**Planning Commission Regular Meeting
August 17, 2023 7:00PM
City Hall
102 Butler Street, Saugatuck, MI**

A. 291, 292, 293, 296, 297, 298, 301 Sugar Hill Ct – Formal Site Plan Review *Pg. 11*

Memo Date:	August 14, 2023	Meeting Date:	August 17, 2023
Request:	Site Plan Review	Applicant:	Brad Rottschafer
Address:	Sugar Hill Ct.	Project Name:	Vine Street Cottages
Parcel:	03-54-009-051 (12-18)	Plan Date:	November 7, 2012
Lot Size:	6.46 acres	Zoning District:	R-1 Peninsula West
Complete:	Yes	Recommendation:	Conditional Approval
Staff:	Ryan Cummins	Consultant:	David M. Jirousek, AICP

PROPOSED PRIVATE ROAD CROSS SECTION
 N.T.S.

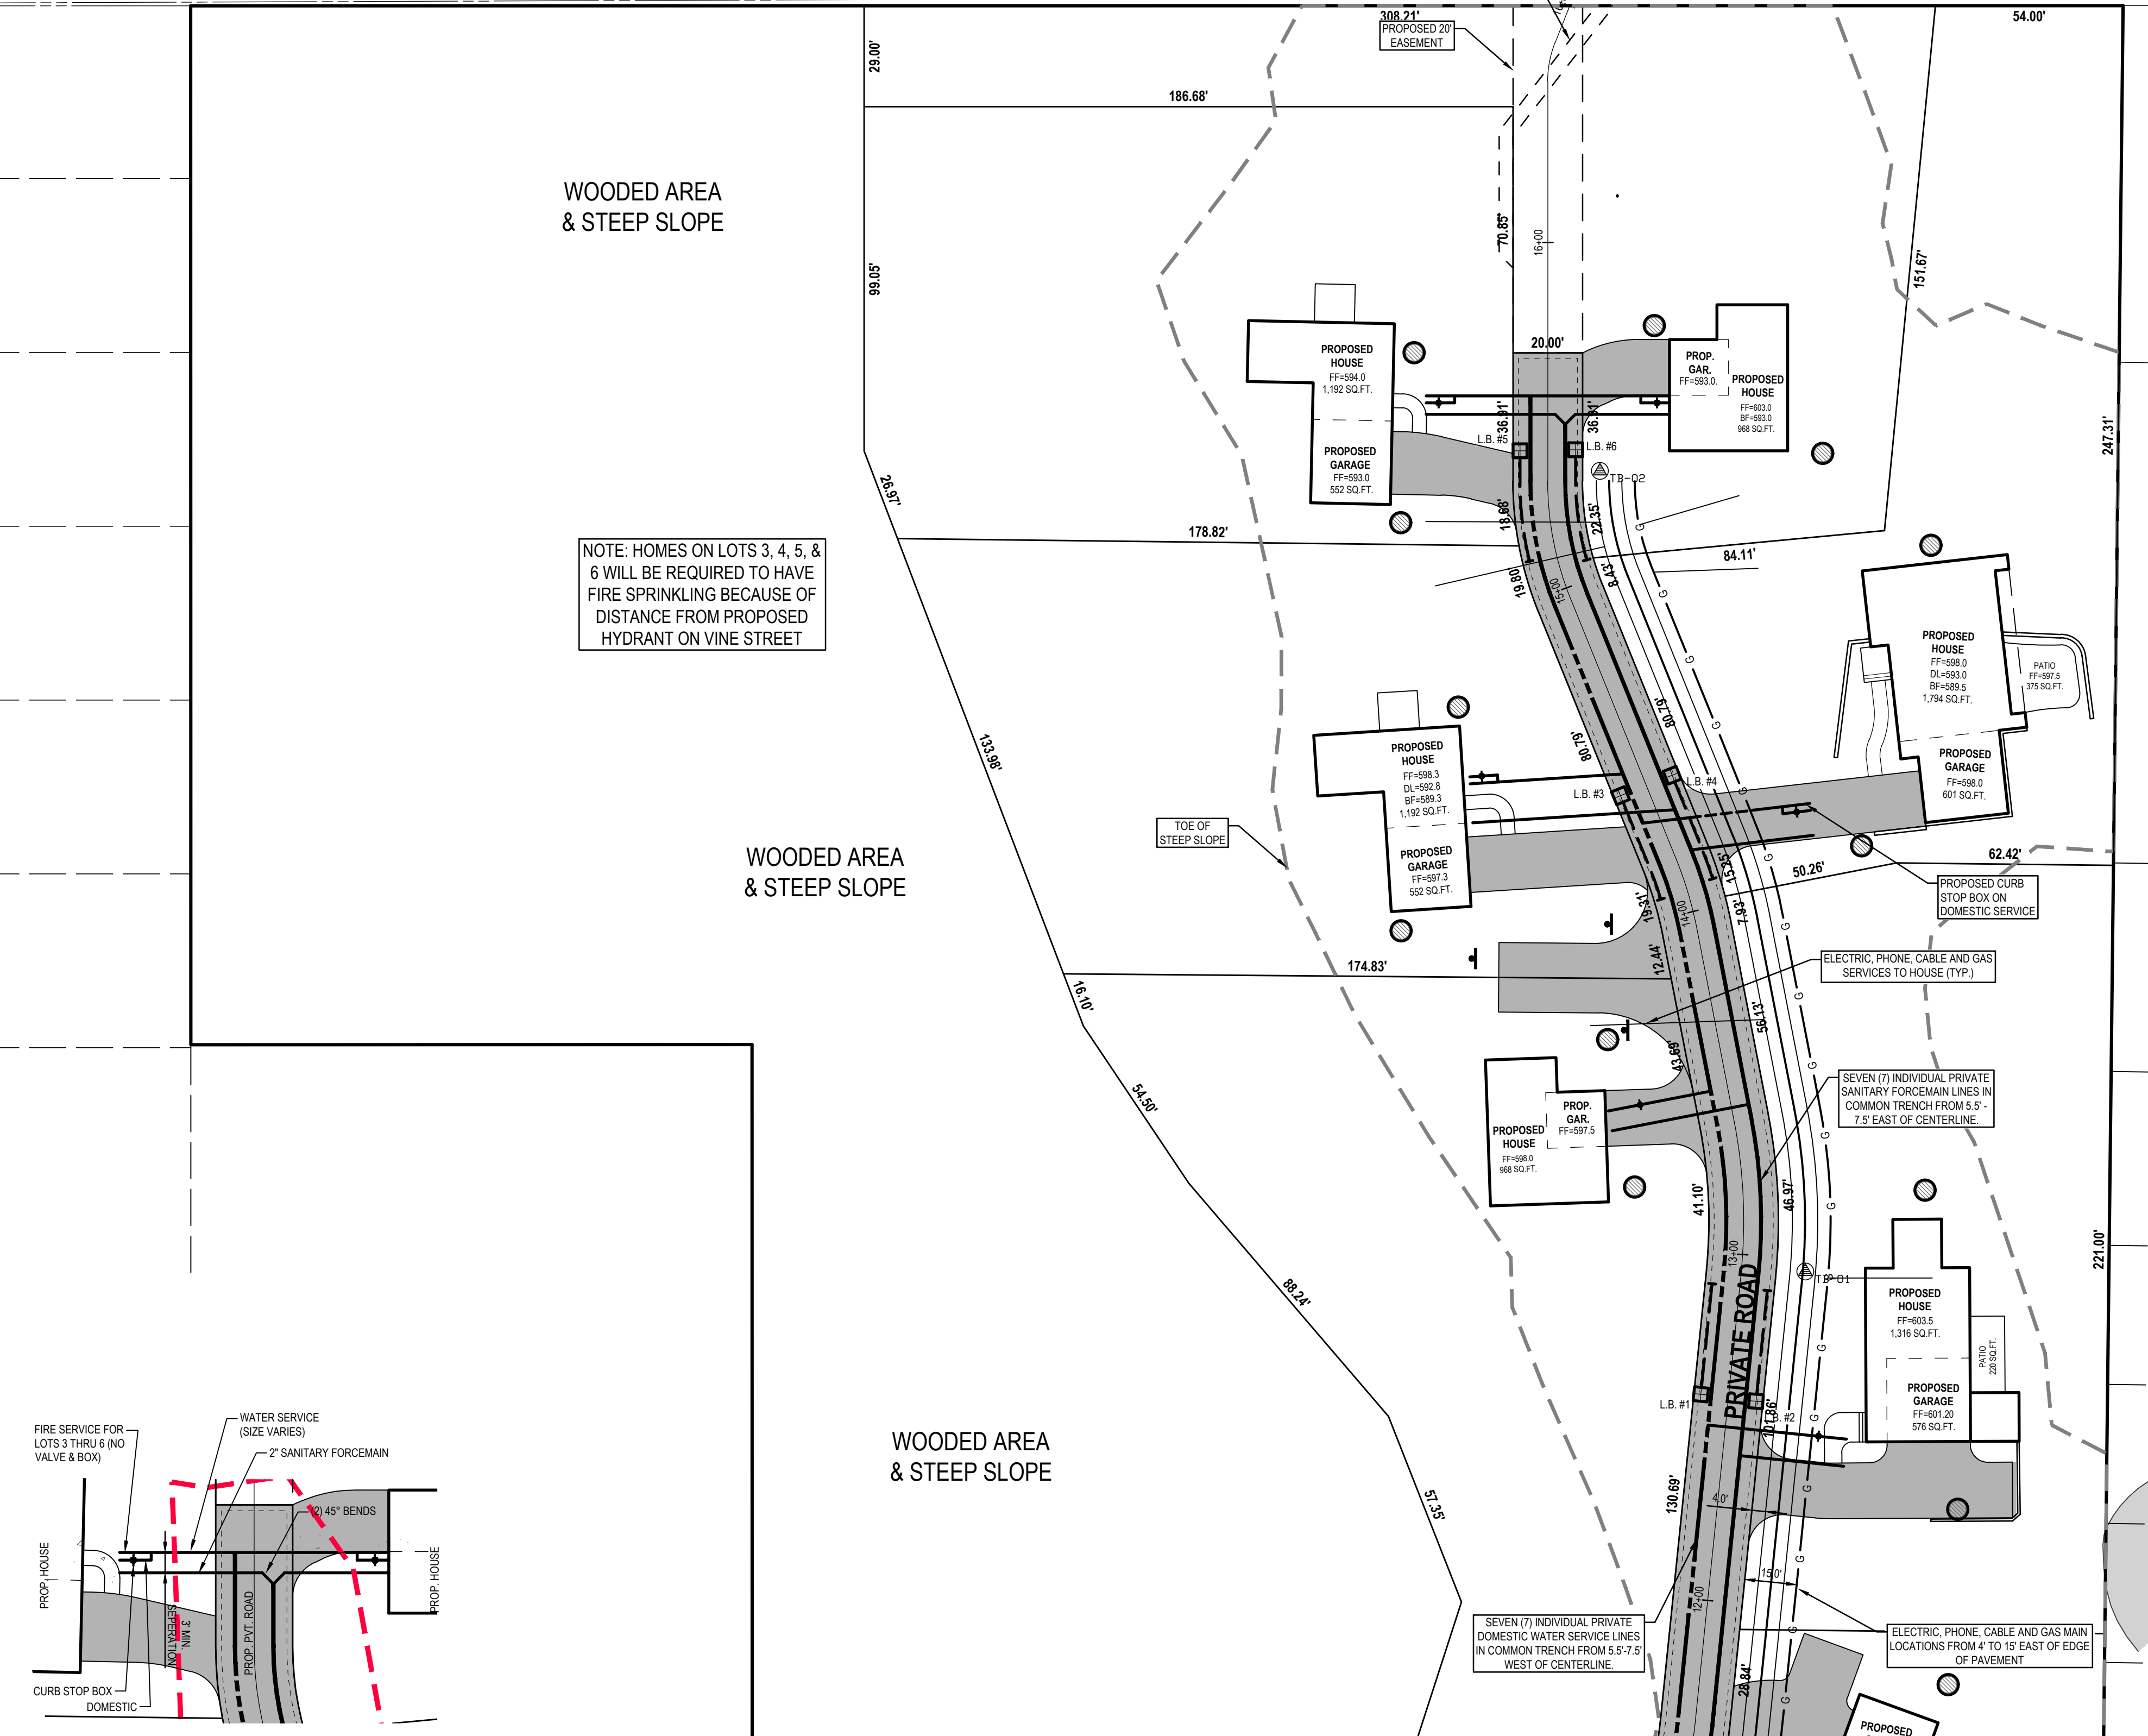
- *The required weight capacity of the road is now labeled and noted on the fire apparatus turn around detail on sheet C-205 and on the private road cross section detail on sheet C-400.*

FIRE TRUCK APPROACH & DEPARTURE DETAIL
 HORIZ. SCALE: 1" = 10'
 VERT. SCALE: 1" = 1'

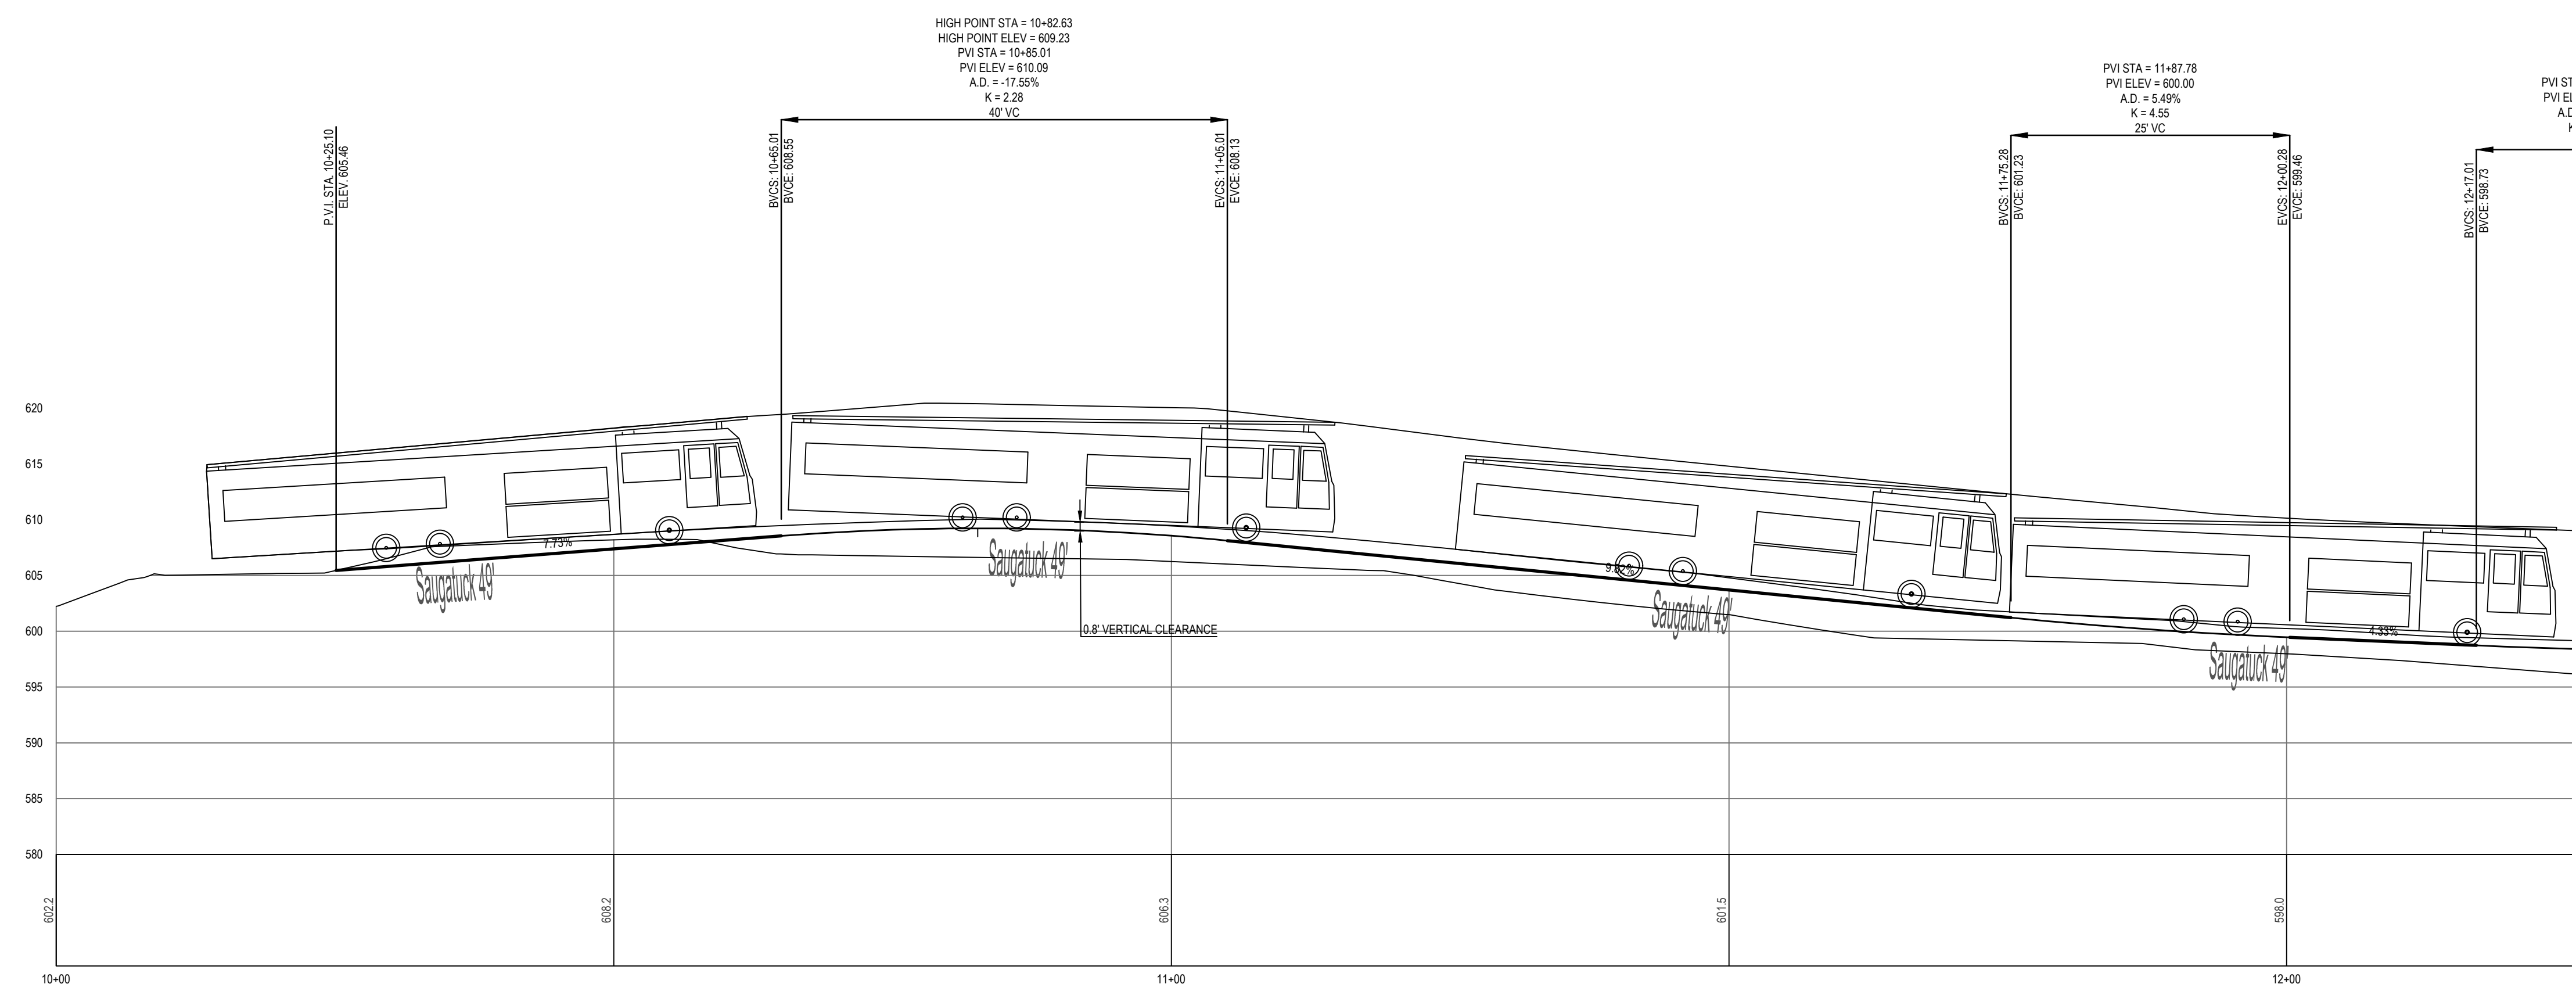
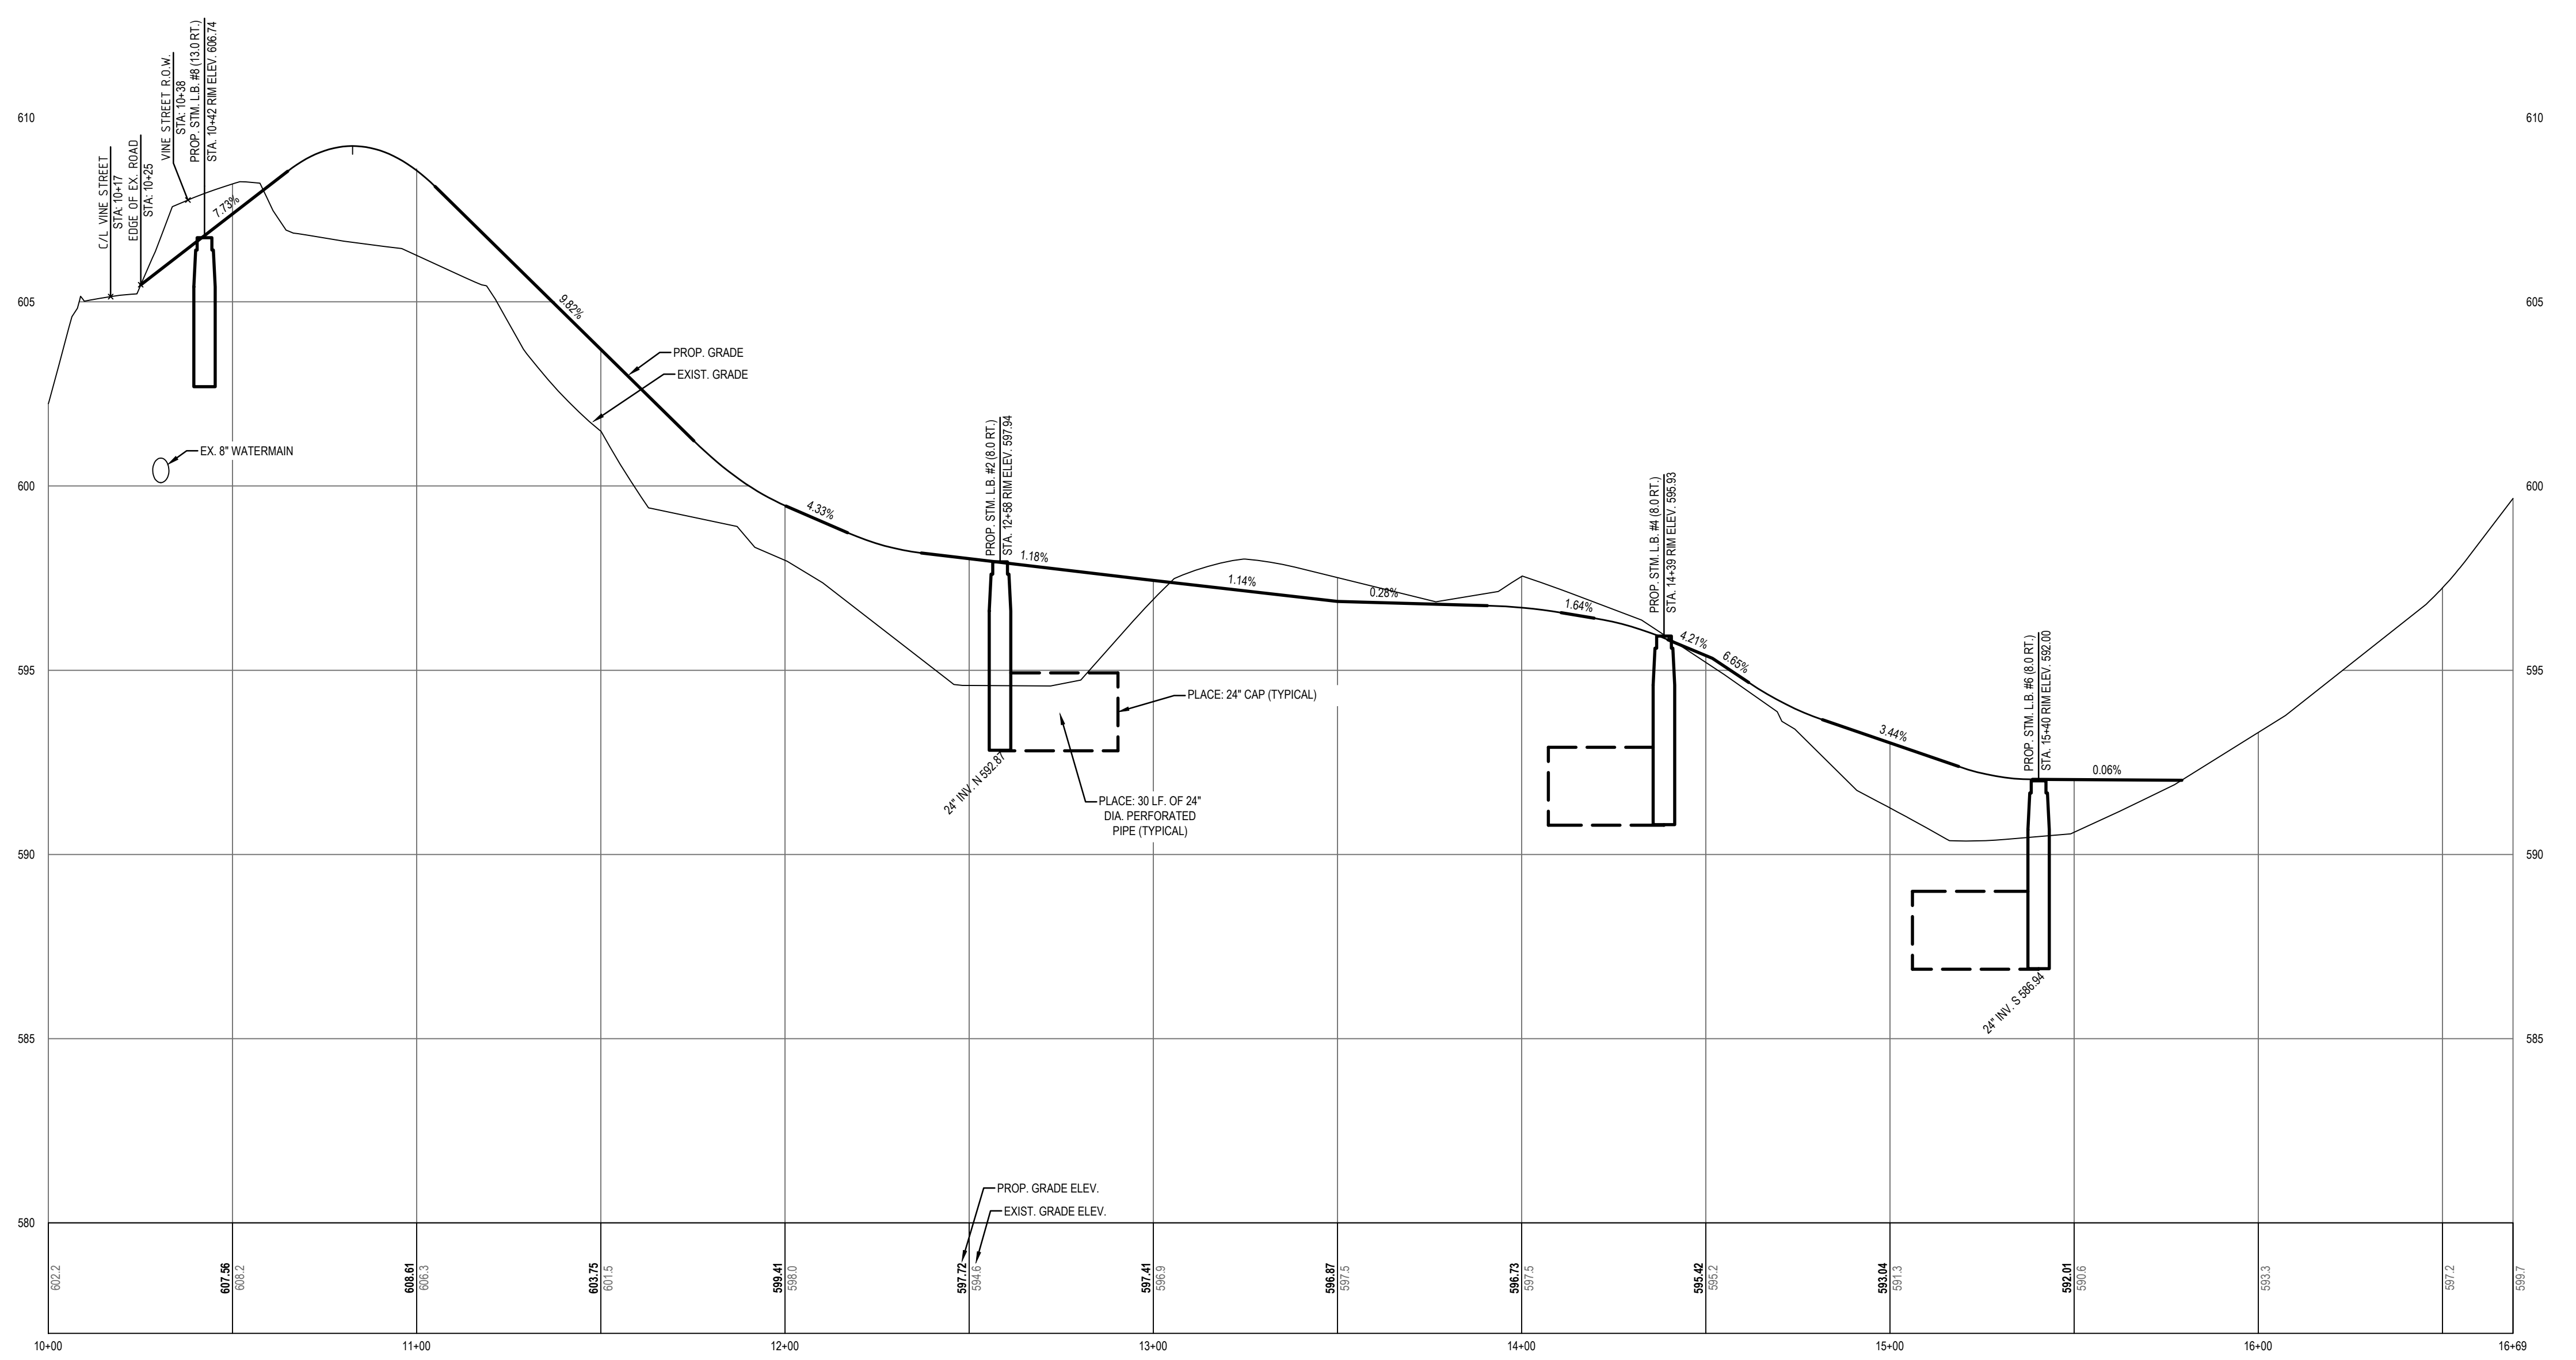
- *The minimum clear height note has been added on sheet C-205*
6. Road shall not exceed the 10% maximum grade. (IFC 503.2.7) ***Grade is does not shown in the plans provided, please include in revised submittals.***

- *The private road profile on sheet C-401 shows that no portion of the private road exceeds 10% grade.*
